TECHNICAL SERVICE BULLETIN

Subject: TSB for ECN 151103 – New Gasket for the 97118731 Screened Float Assembly

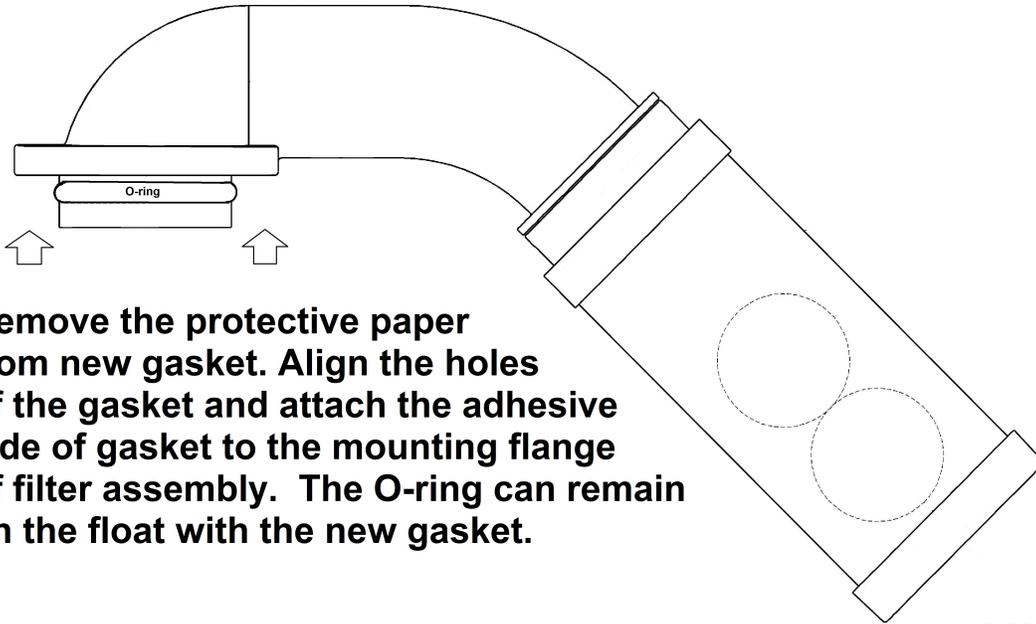
Reason for Change

To improve the performance of the machine.

Reference Instructions – When replacing the 97118731 Screened Float Assembly, order the new gasket part number 247660 also. Installation procedure: Remove the existing O-ring gasket from the screened float and replace it with the 247660 gasket.

Remove the protective paper from new gasket. Align the holes of the gasket and attach the adhesive side of gasket to the mounting flange of filter assembly. The O-ring can remain on the float with the new gasket.
